COTTAGE GROVE CITY COUNCIL

- J Glacial Valley Park Building - Change Order #1
Staff Recommendation: Approve Glacial Valley Park change order #1 in the amount of \$42,434.61.
- K Marathon Community Investment Grant Acceptance
Staff Recommendation: Accept and approve the Marathon Community Investment Grant in the amount of \$5,000.00.

GLACIAL VALLEY PARK BUILDING

E1.00

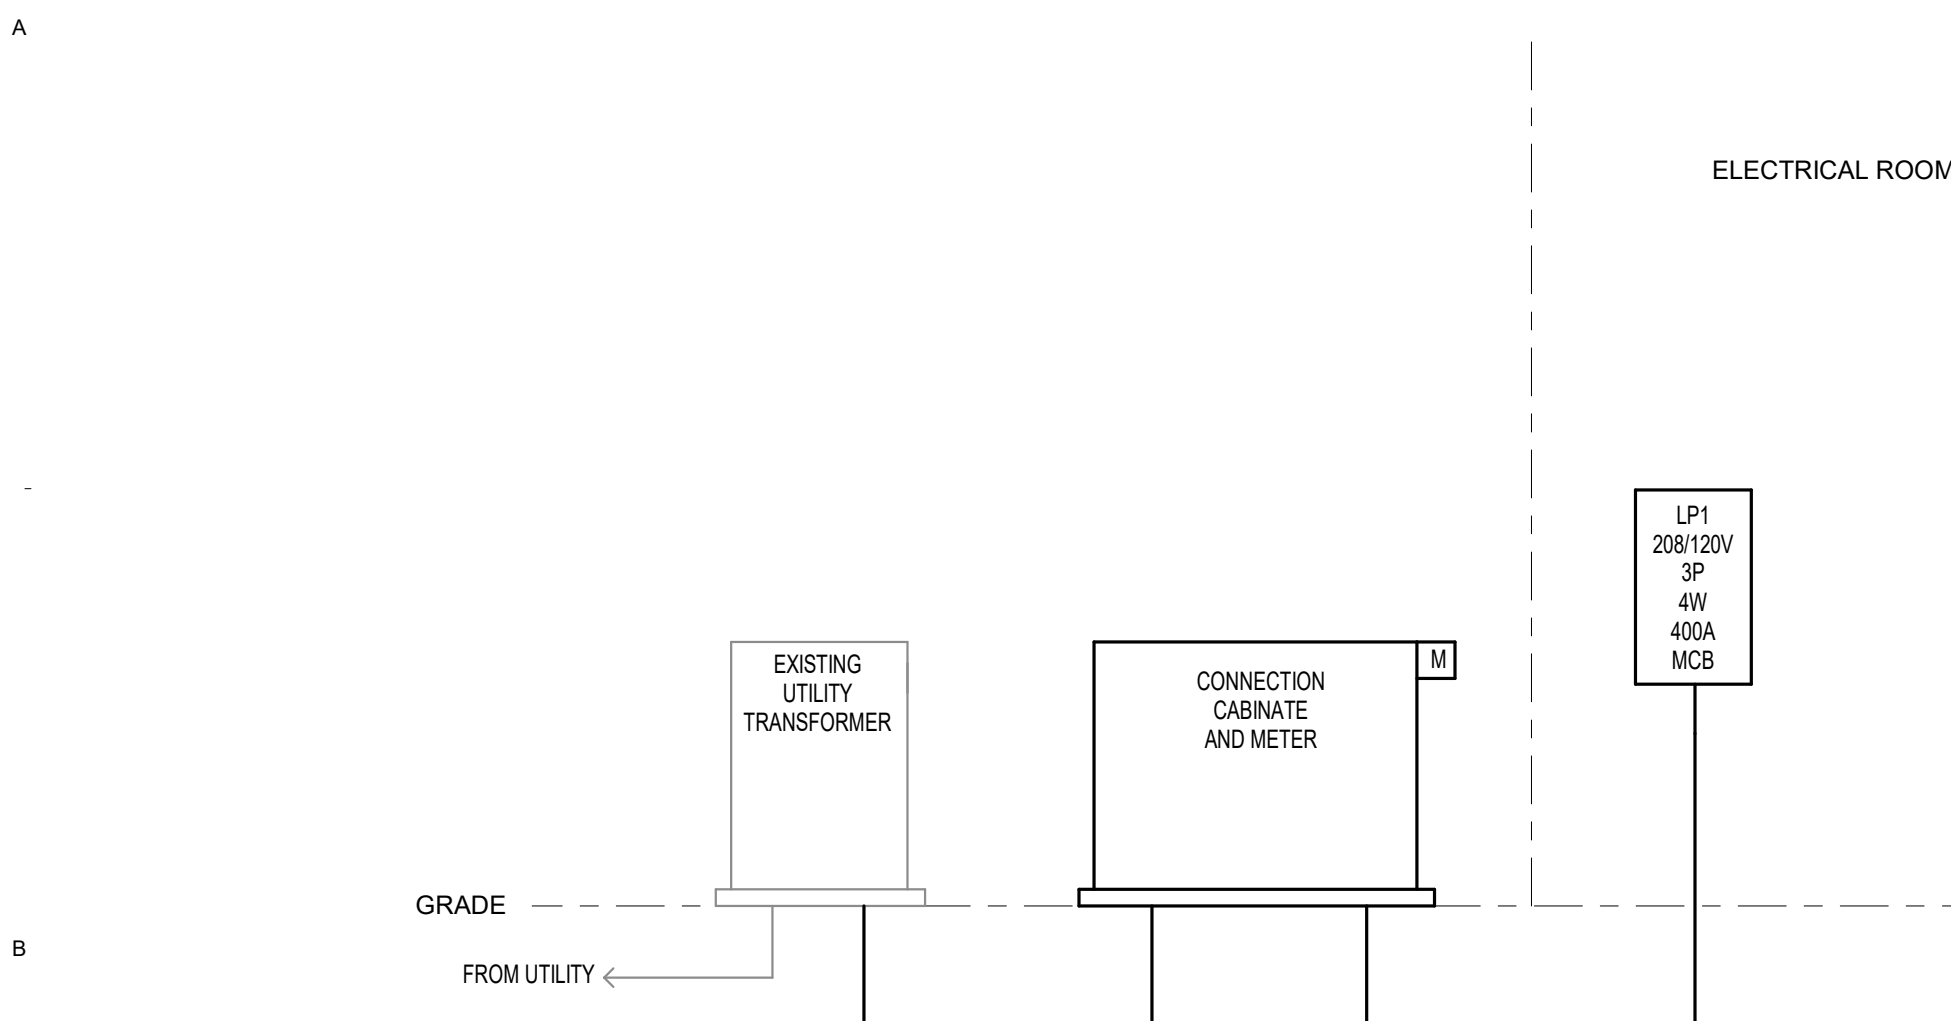
Item	Description
1	Electrical Clarifications
1.1	See revised sheet E1.00 for updated locations of card access devices/head end equipment, patch panel, and security head end equipment by Owner.

Item	Description
5	AED Station
5.1	Refer to revised sheet E1.00 for modifications to the power and systems plan to accommodate a new wall-mounted AED station.

6.5	See revised cover sheet E0.00.
6.6	See revised sheet E1.00 for plan and panel revisions.
6.7	See revised sheet E2.01 for the added roof plan.
6.8	See revised sheet E3.00 for updated motor schedule.

A2.001

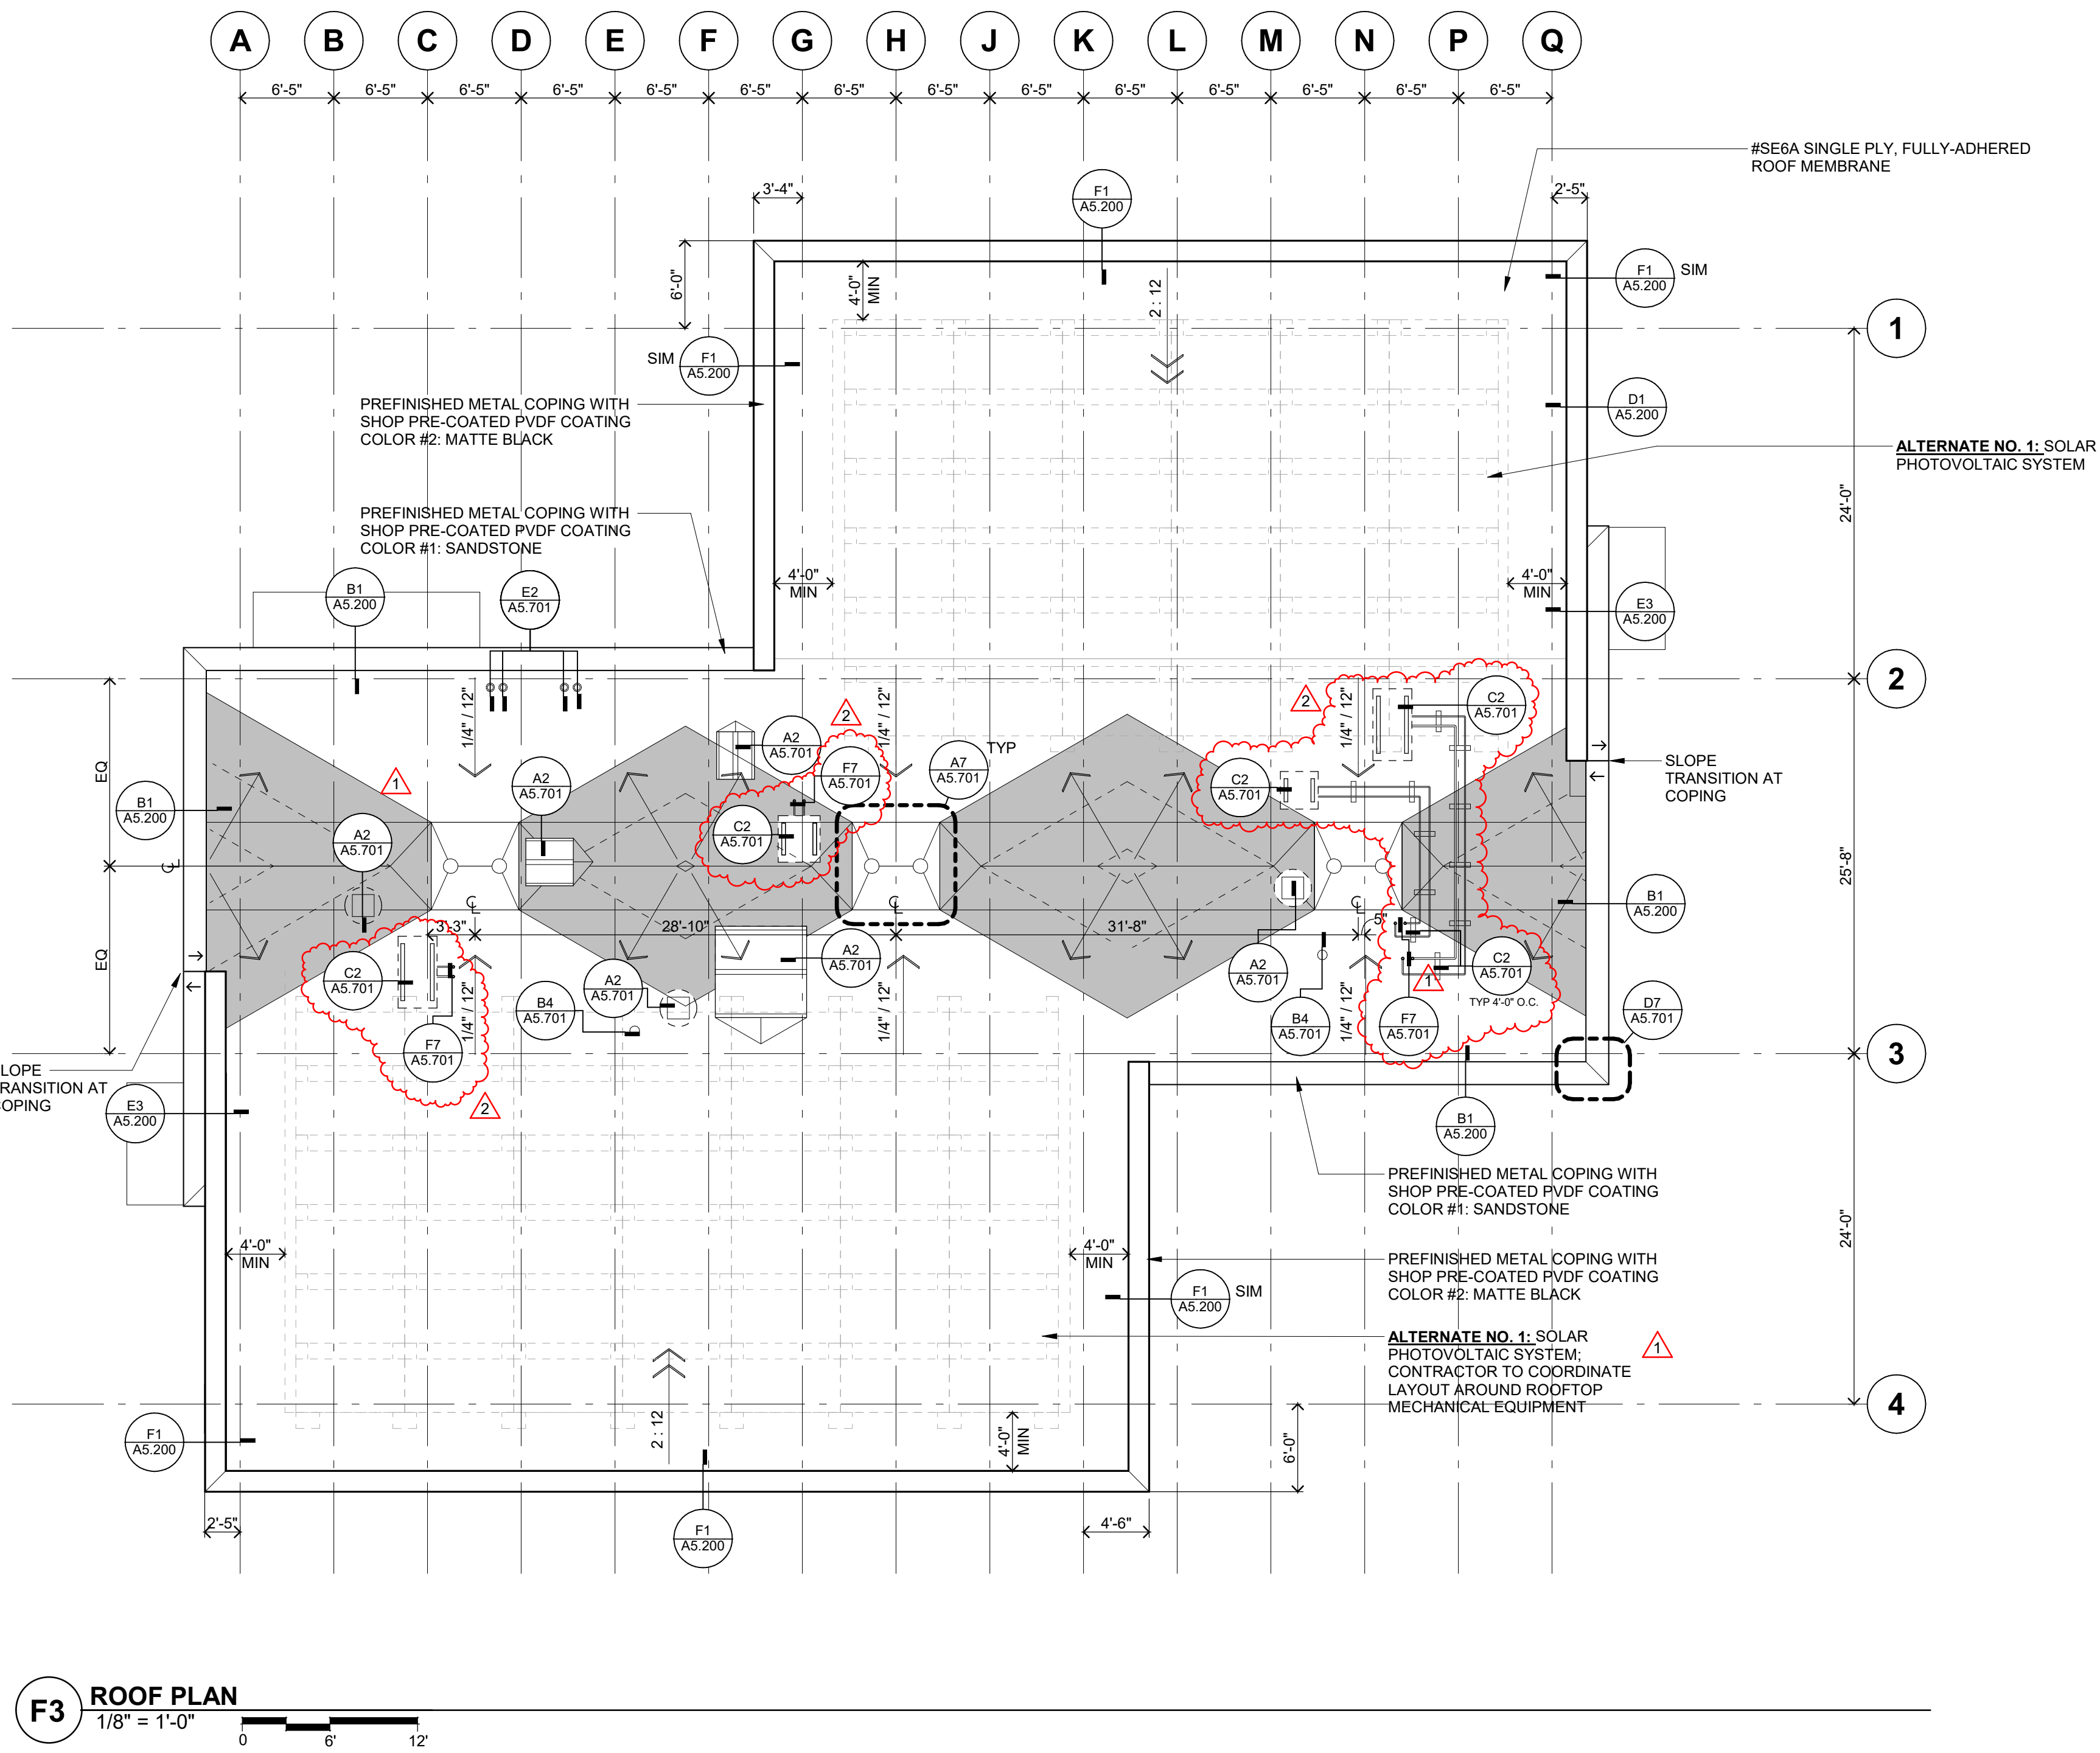
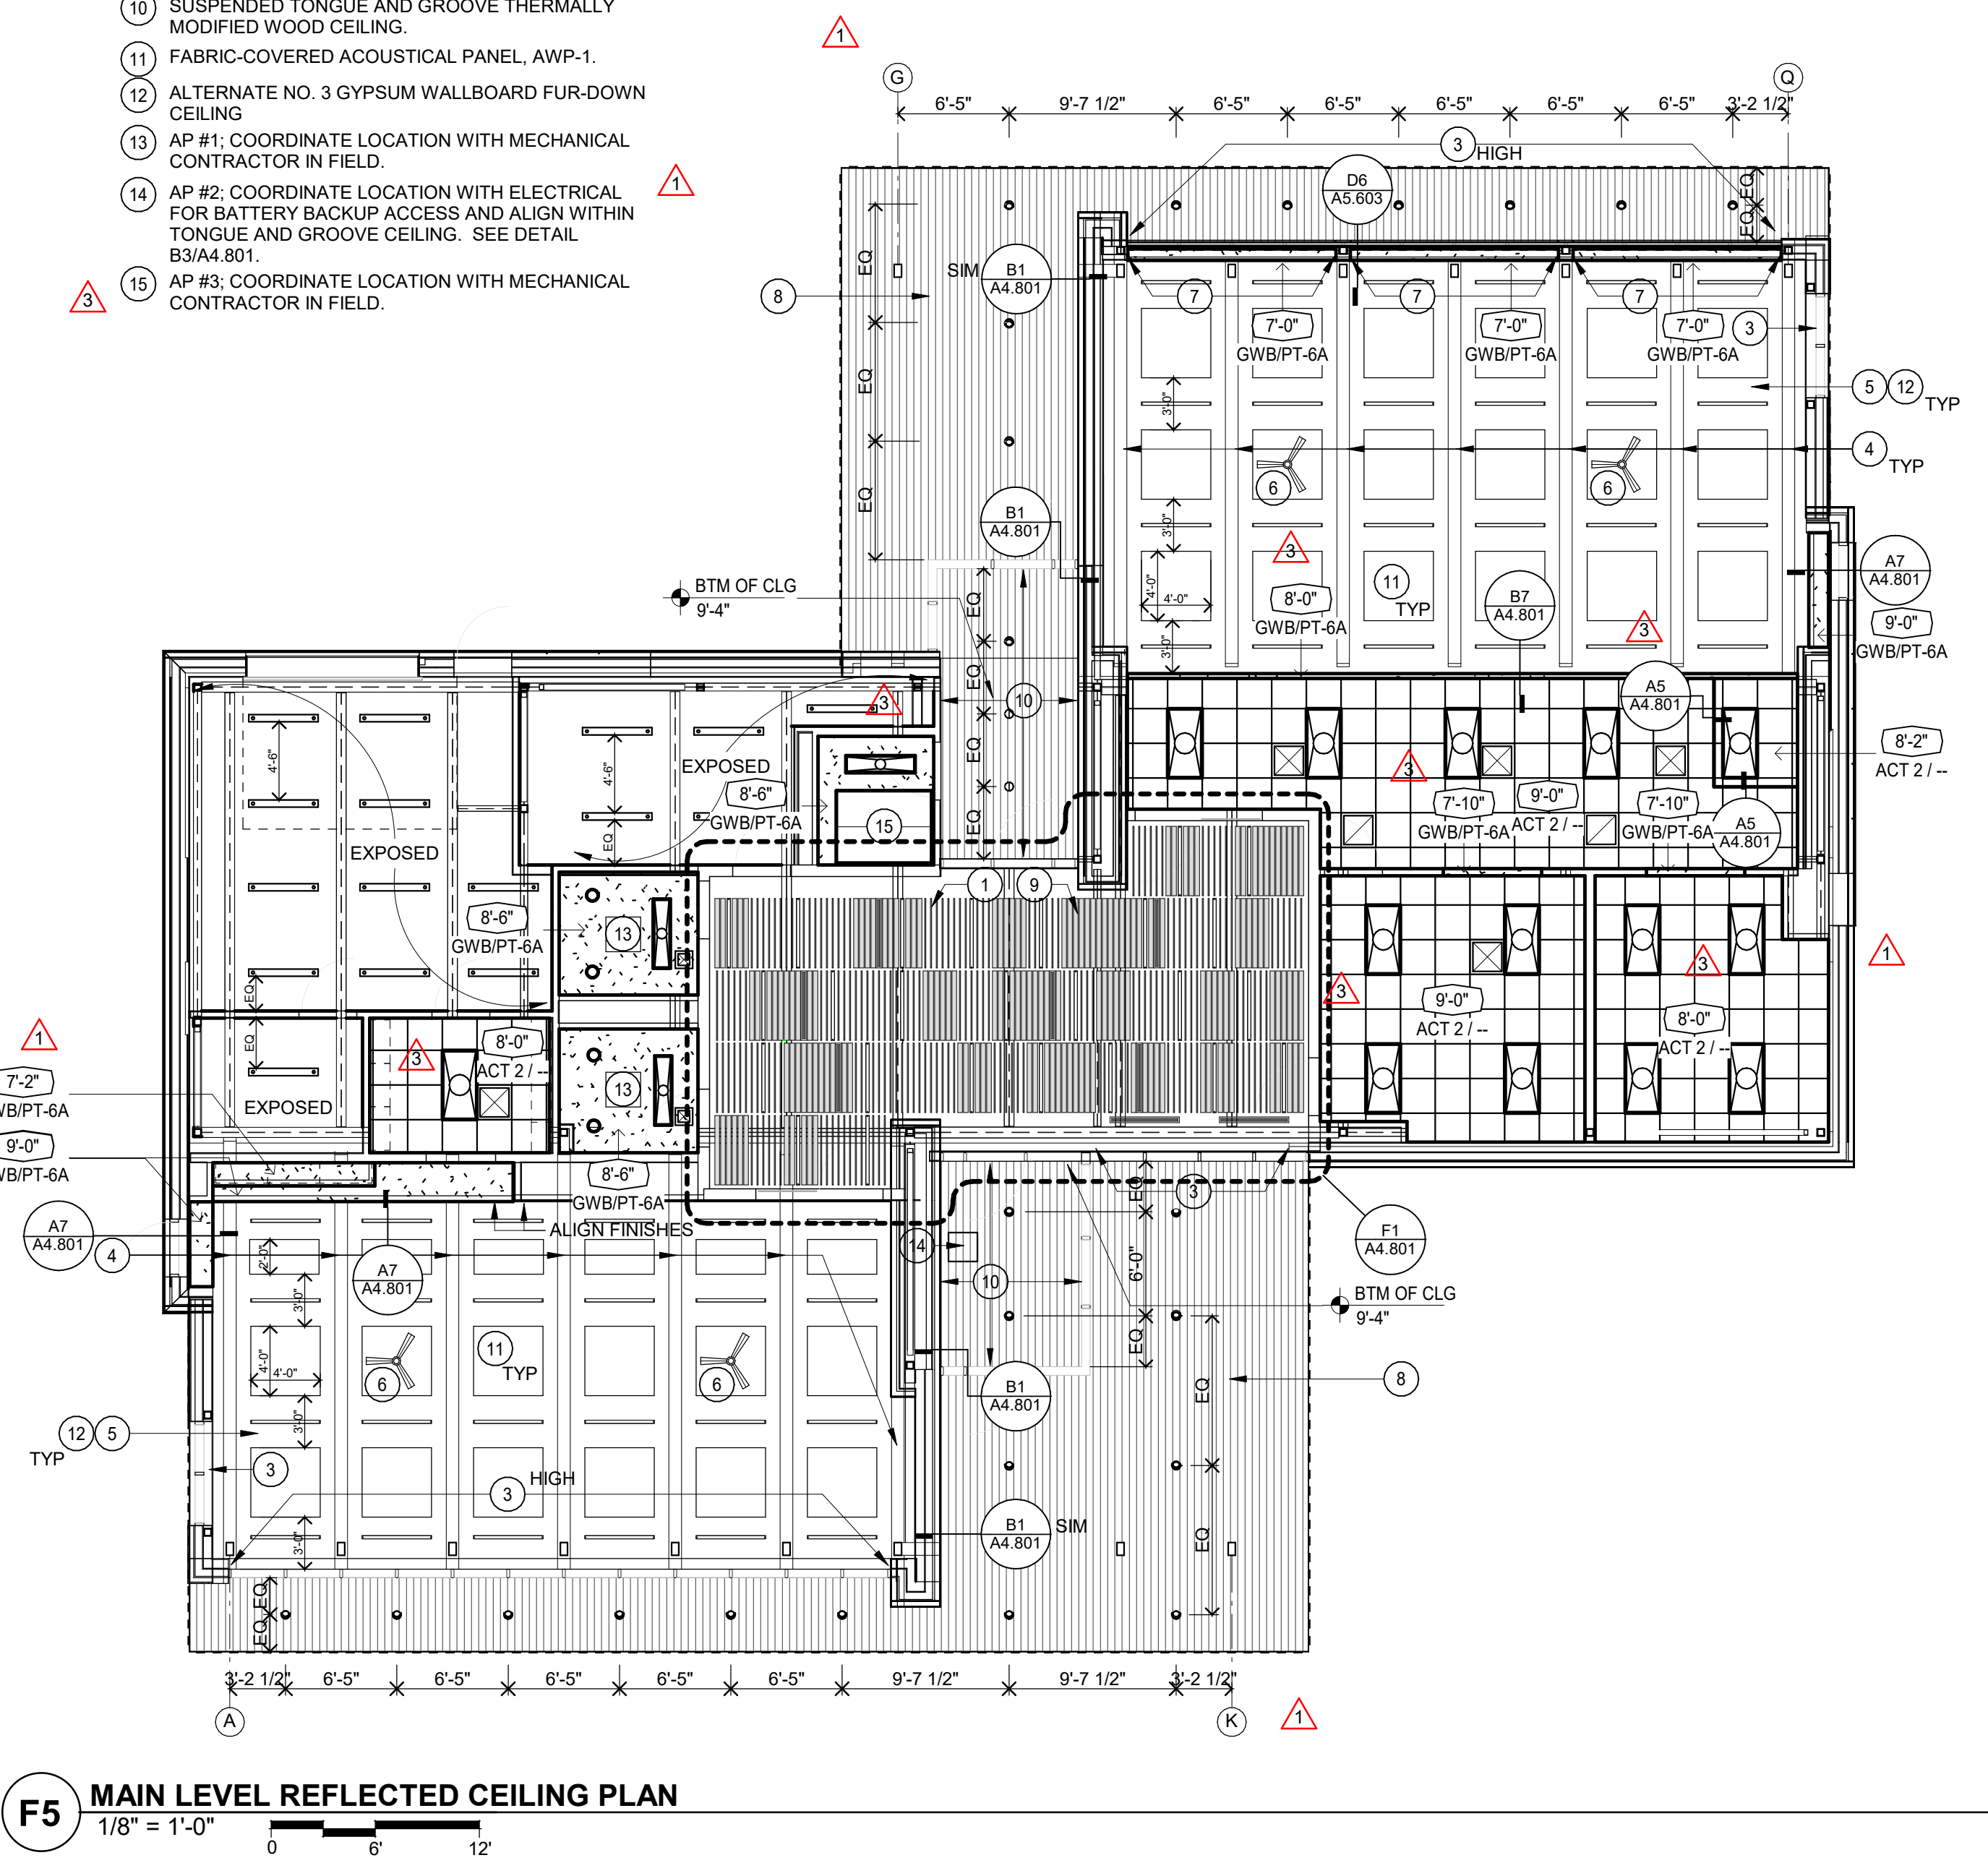
4.8	See sheet E1.00 for revisions to lighting in Toilet 106.
4.9	Refer to sheet A2.001 for revisions to ceiling heights, ceiling transitions, and diffuser locations.

4.10	Refer to sheet A2.001 for lighting reductions and modified access panel in Toilet 106. Added Access panel (AP #3) shall be ceiling mounted 48" x 64" double door with cam latch per the attached drawing from Nystrom or equal.
